Village of Winnetka

Design Review Board/Sign Board of Appeals Regular Meeting

a. Case No. 25-03-SU: Hubbard Woods Train Station (1065 Gage Street): Certificate of Appropriateness to allow renovation of the existing train depot and train platform and construction of a new pedestrian bridge, new accessible ramps, new stairs and elevators to the train platform, and new warming shelters. The Village Council has final jurisdiction on this request. This item was continued from the March 20, 2025, Design Review Board meeting.

Attachment A1: Applicant's Response to DRB Comments at April 17, 2025, DRB Meeting

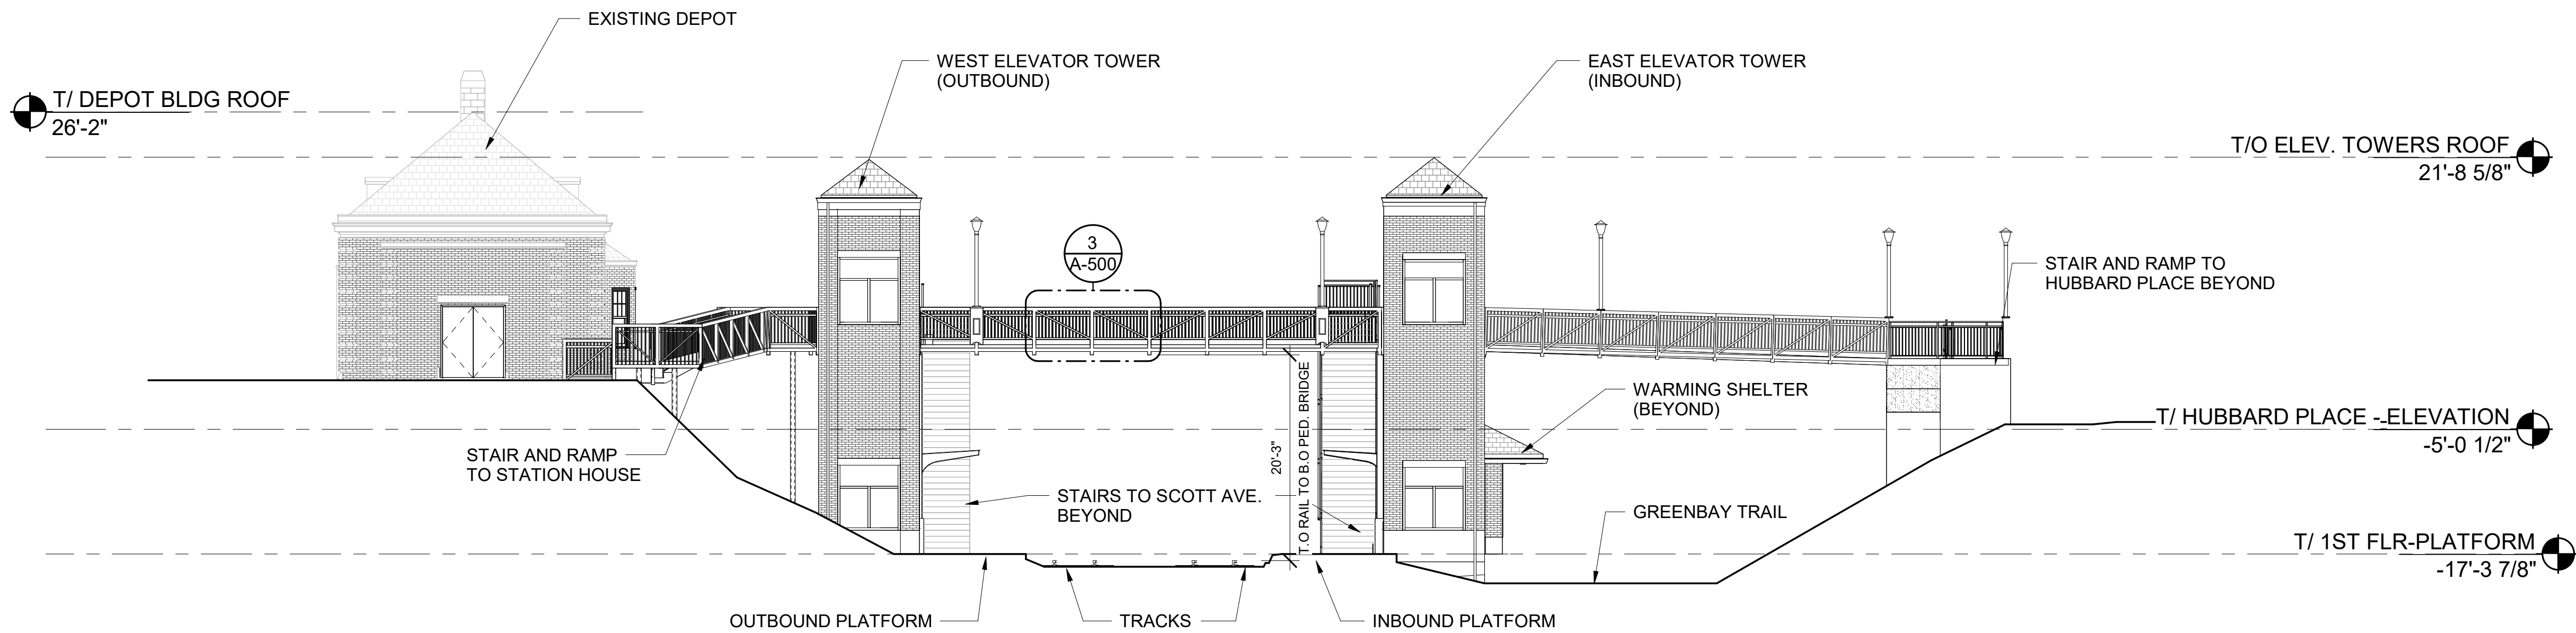
TYLin responded to this comment during the Design Review Board meeting on 4/17/25 that the design of the elevator towers was modified per direction of the State Historic Preservation Office (SHPO) to differentiate the towers from the architectural period of the historic depot building. The current design of the elevator towers (2021/2024) received approval from FTA and concurrence from SHPO.

Prior design of the elevator towers (2020) reflects modifications that the Winnetka Design Review Board members requested, however, the SHPO rejected the previous proposed tower design due to imitating or copying overall elements and not differentiating new construction from that of the historic depot.

The Village of Winnetka, the Winnetka Historical Society, SHPO, and FTA representatives were present at the Consulting Parties Meeting held on 1/7/2021 and agreed upon the modifications to the elevator towers.

Scope Element 2: Elevator Towers and Pedestrian Bridge

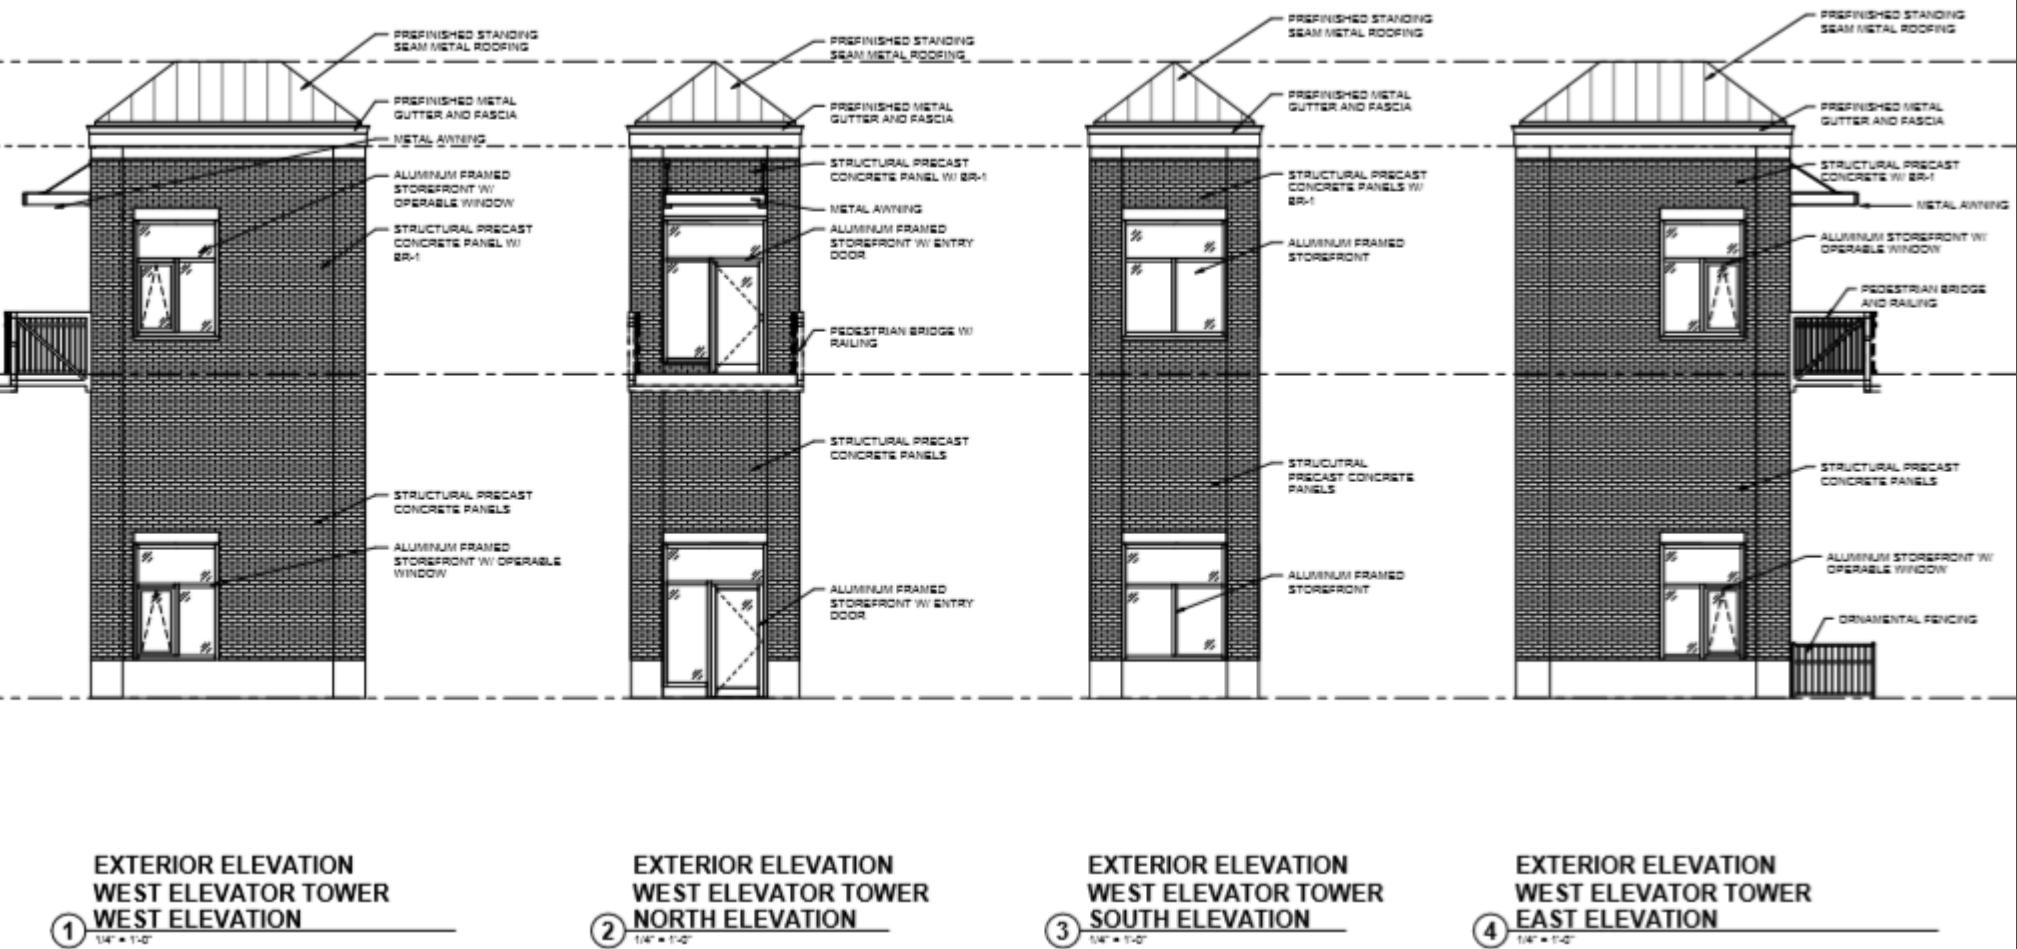
The roof style of the elevator towers is different from the one on the depot. They are seam metal with lower hip and no eaves.

3 PEDESTRIAN BRIDGE TYPICAL RAILING ELEVATION
1/2" = 1'-0"

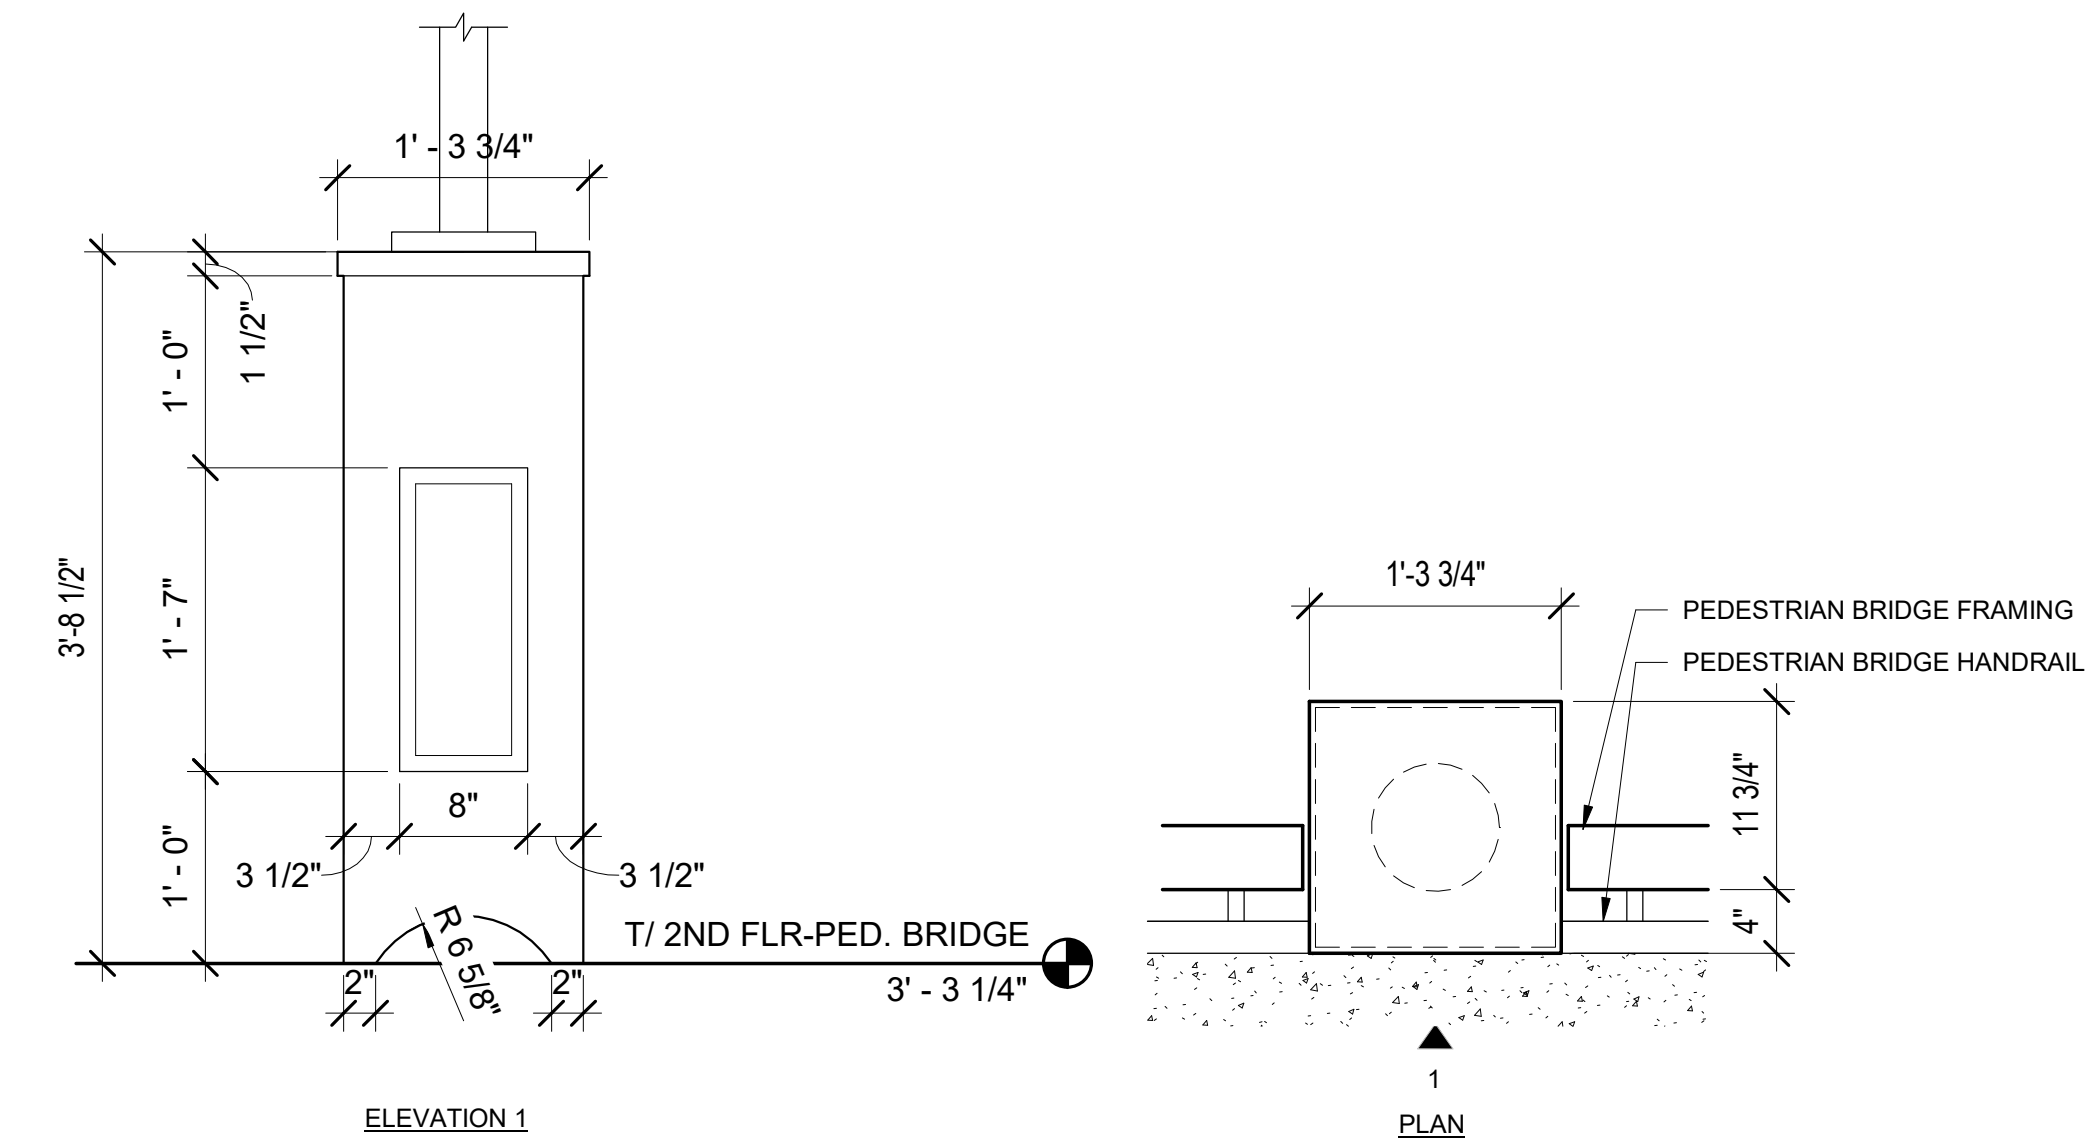
2. H. Niehoff requested that Metra consider matching the pedestrian bridge lantern style and quantity to the Elm St. station.
The design intent is to use the same lantern style fixture as used at the Elm Street station at the Winnetka Station including the fixtures on the pedestrian bridge. These are shown on Plan Sheet A-300. Pedestrian bridge lighting intent is also shown on plan sheet E-501. (See attached sheets). Rendering exhibits will be revised accordingly.

LIGHT POST BASE TO MATCH THOSE AT
WINNETKA STATION PEDESTRIAN BRIDGE
